# Berry Holdsworth

## Design Excellence Report

# Response to Design Review Panel

The following document outlines the key design changes and refinements that have been undertaken to further develop the design and to respond to the feedback provided by the Design Review Panel February 2022. Following is some high level commentary to assist when reviewing the submitted documents.

## Amended Childcare Scheme

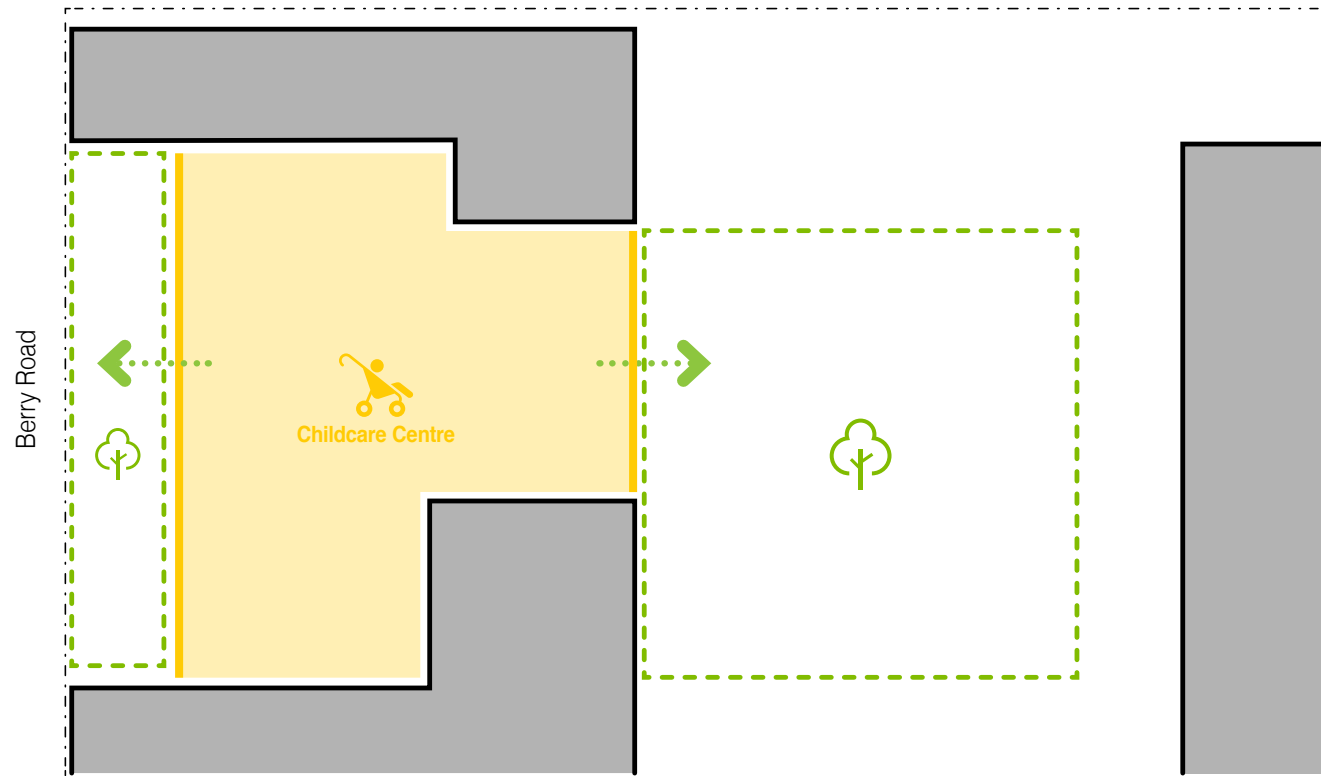
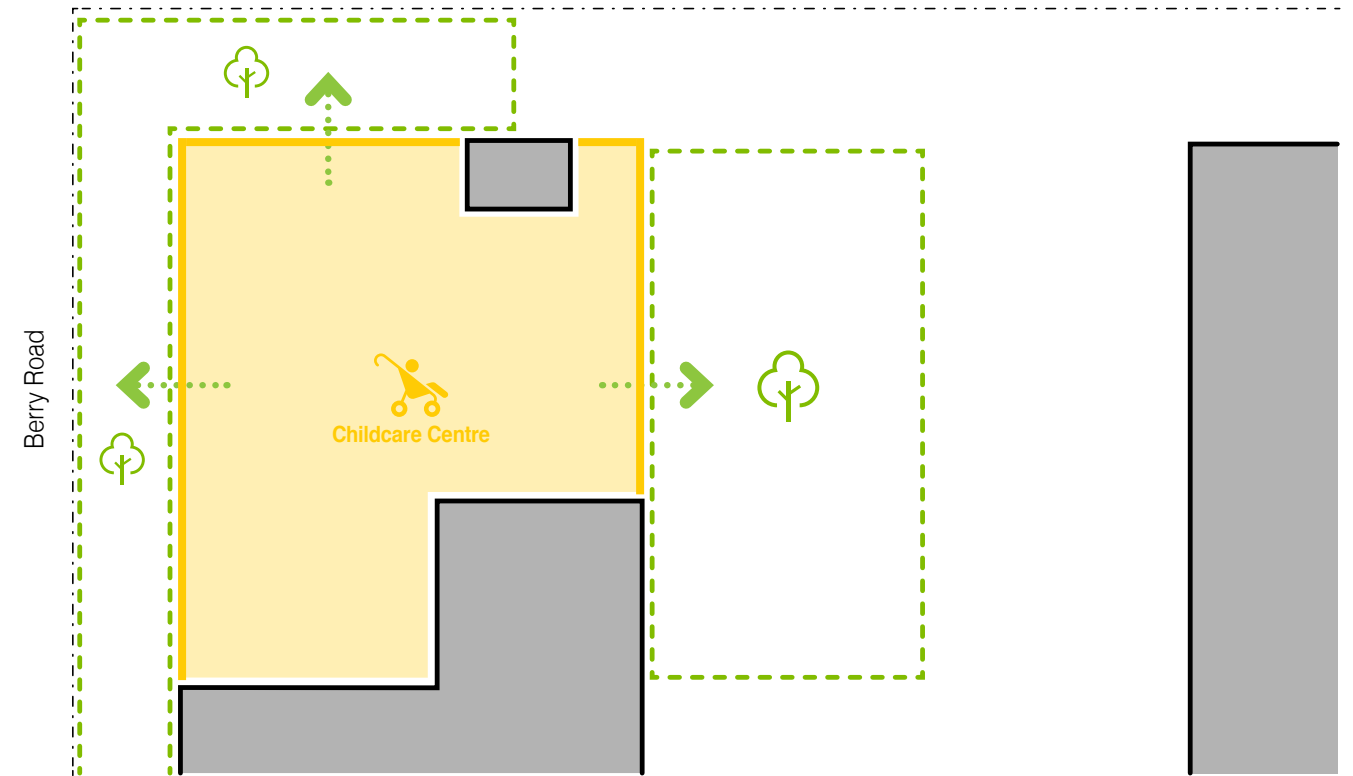
East West Link  
The east west link has been reconfigured to allow northern frontage to the childcare centre. The community centre has also been replanned to take advantage of this newly created northern frontage, the following key items are of note:

- The reconfigured childcare centre results in an invaluable covered outdoor play space that can be utilised in all weather and is acoustically separated from the residents over.
- The Community Centre now occupies a prime frontage and is highly visible from Berry Road. The entry is located off the very public east west link and utilises this spaces as external overflow for events.

## Berry Road Townhouses

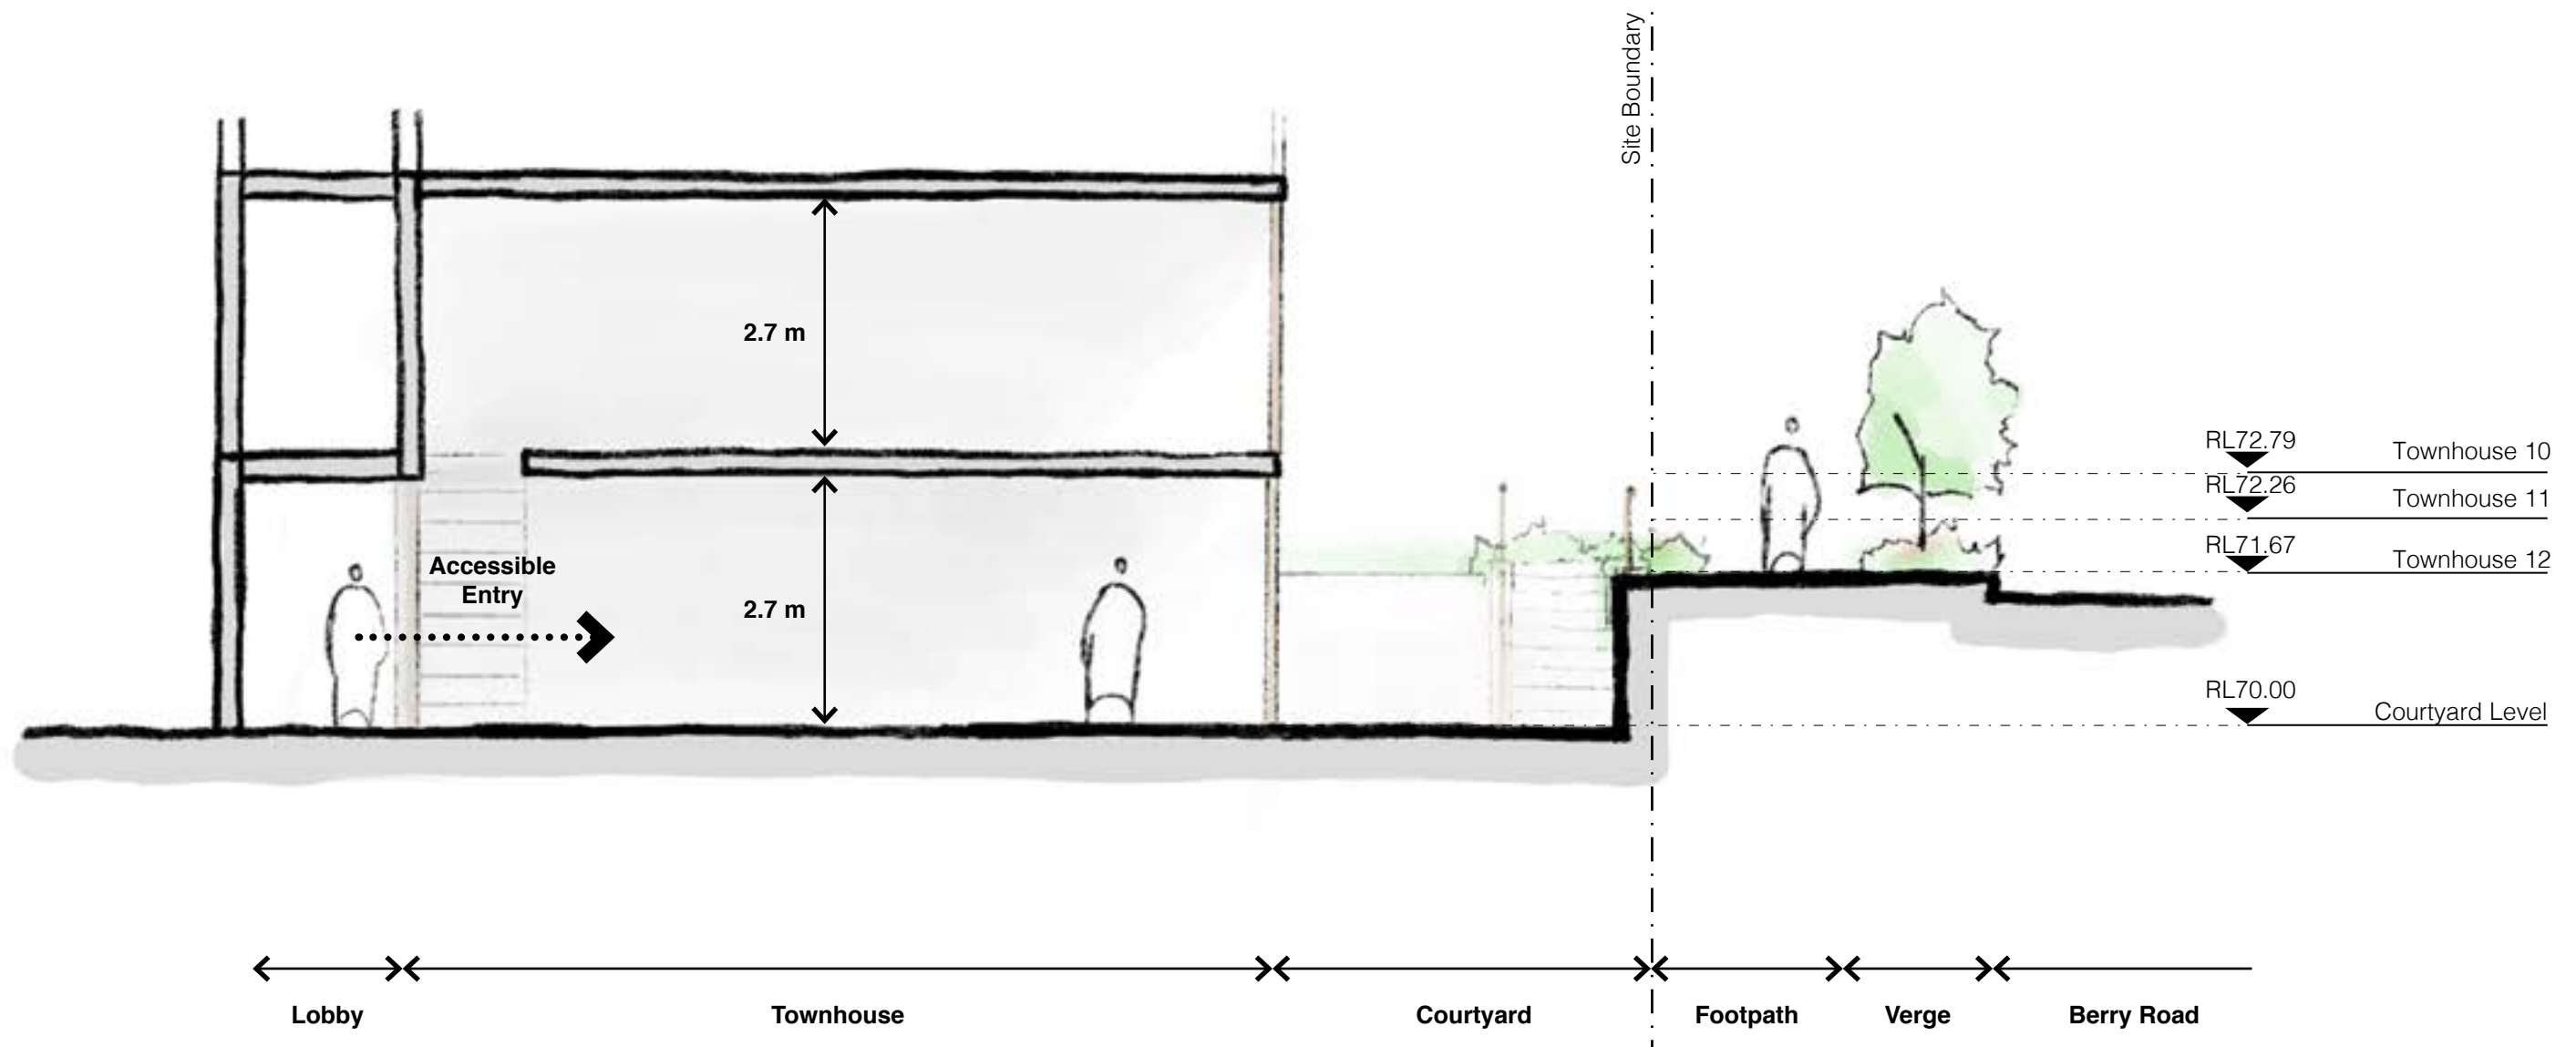
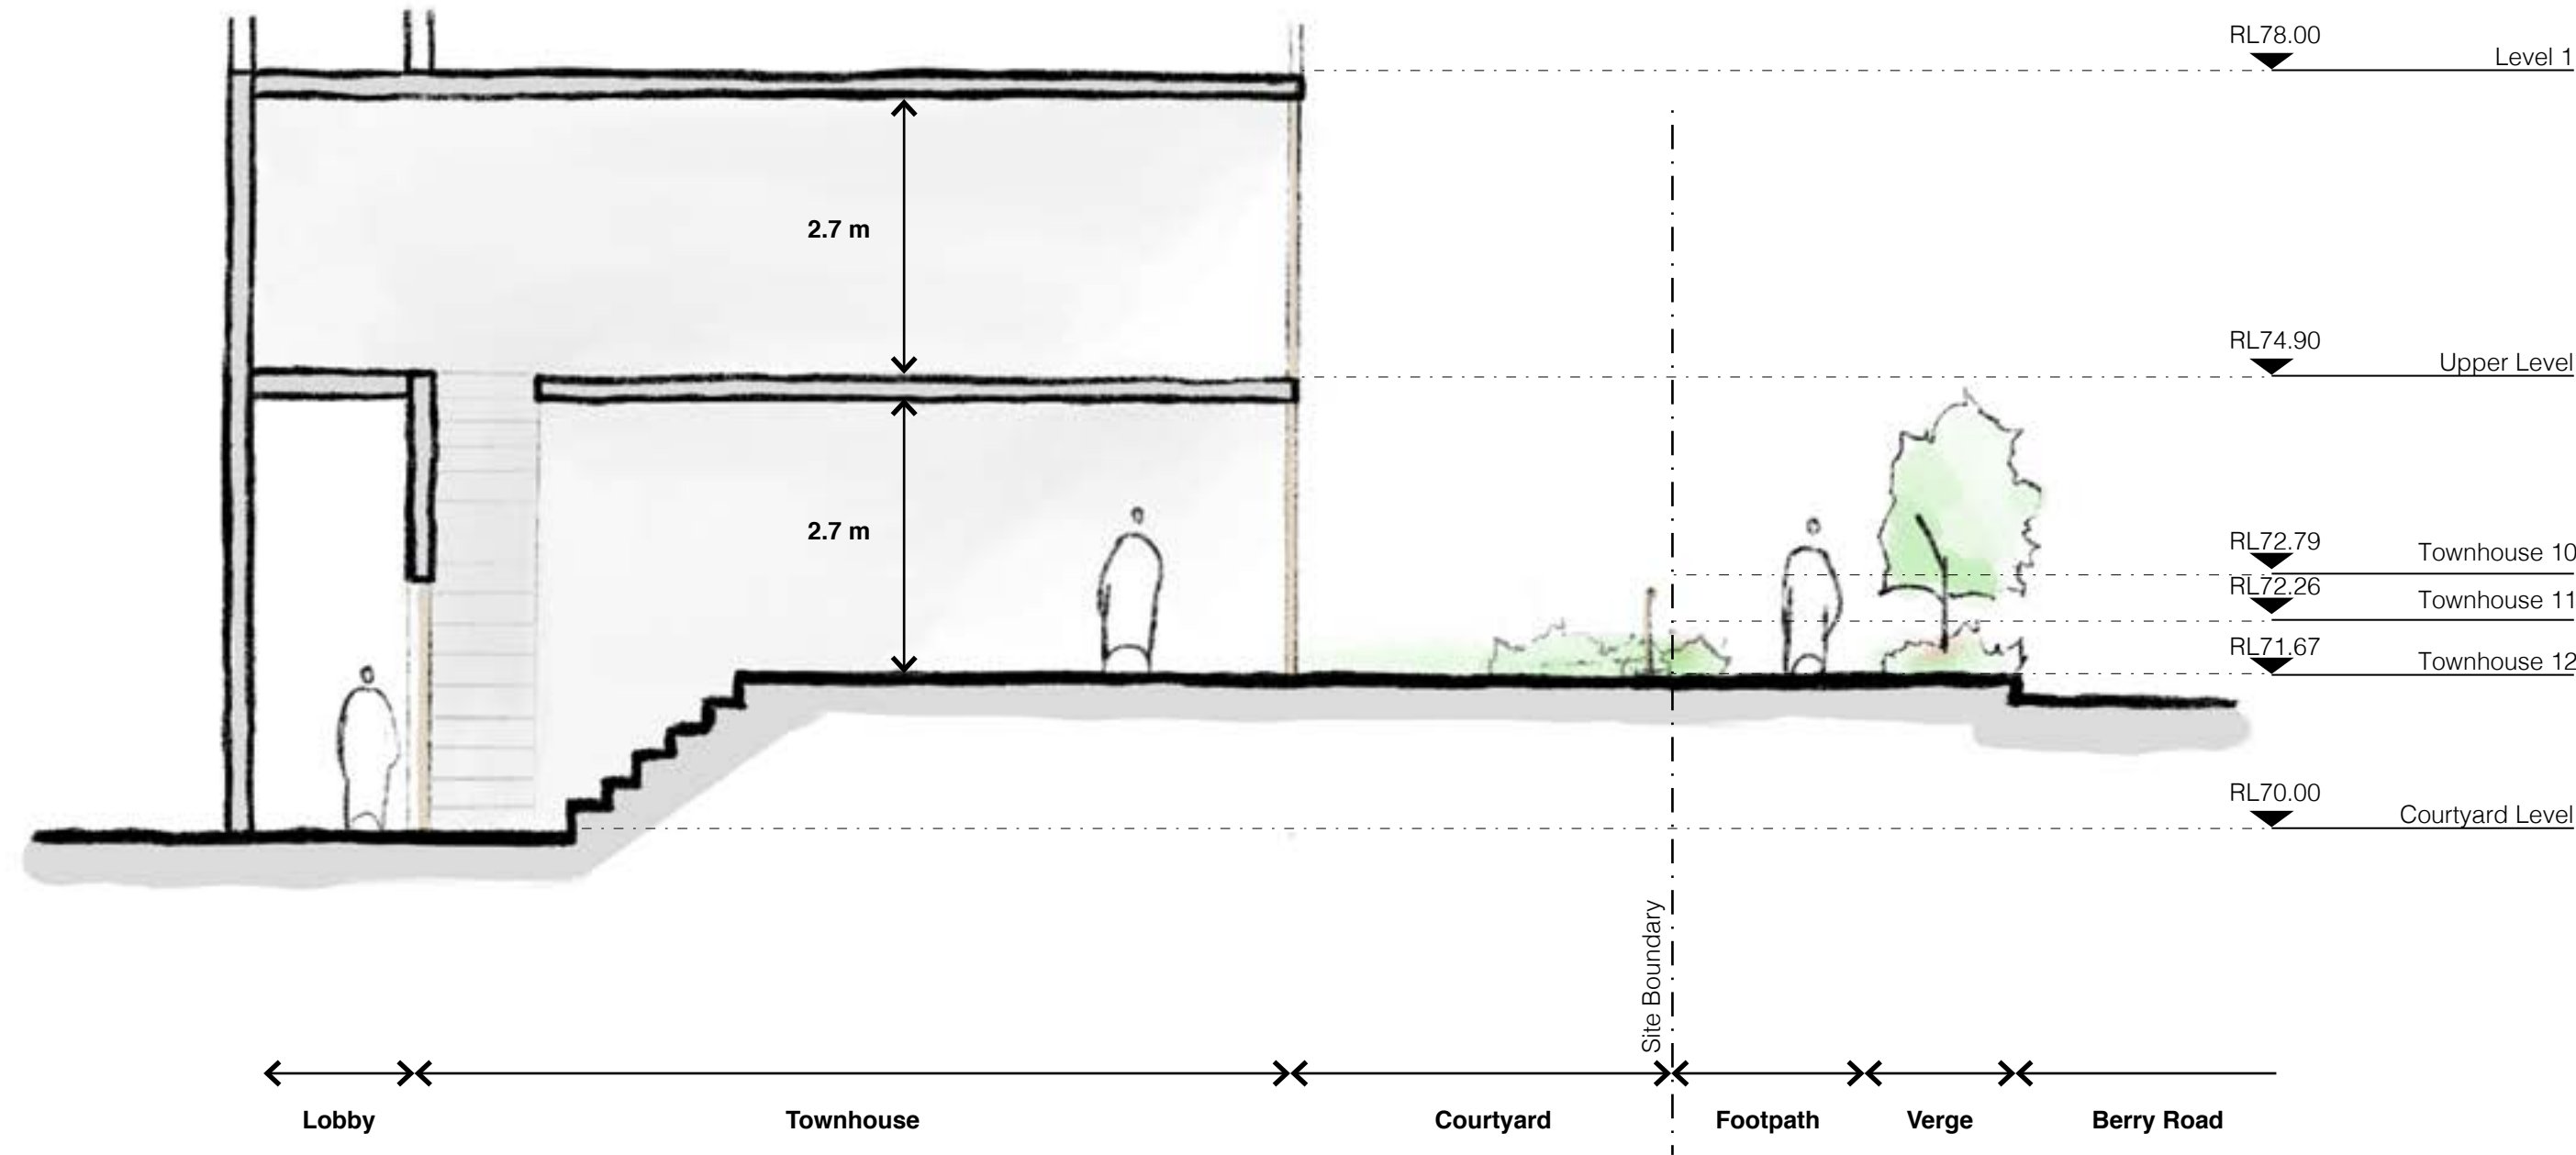
The street fronting dwellings have been further developed including the levels and relationship with the street, the following key items are of note:

- All of the ground level terraces, fronting both the street and internal courtyard, achieve a maximum street setback of 1m or less - except for the 3 terraces facing Berry Street.
- Whilst it is possible to have these align with the 1m max preference, we have proposed an alternative configuration whereby we have increased the floor to floor heights of these terraces maximising access to sunlight and fresh air.
- These terraces receive solar access to their courtyards for a minimum of 2 hours mid winter.
- The lowered courtyards result in a green and private backdrop for the living levels.
- It becomes complicated to raise the internal floor levels given the requirement for an accessible entry. Raising the internal floor level would result in alignment with the 1m max street frontage interface however would reduce their accessibility internally.
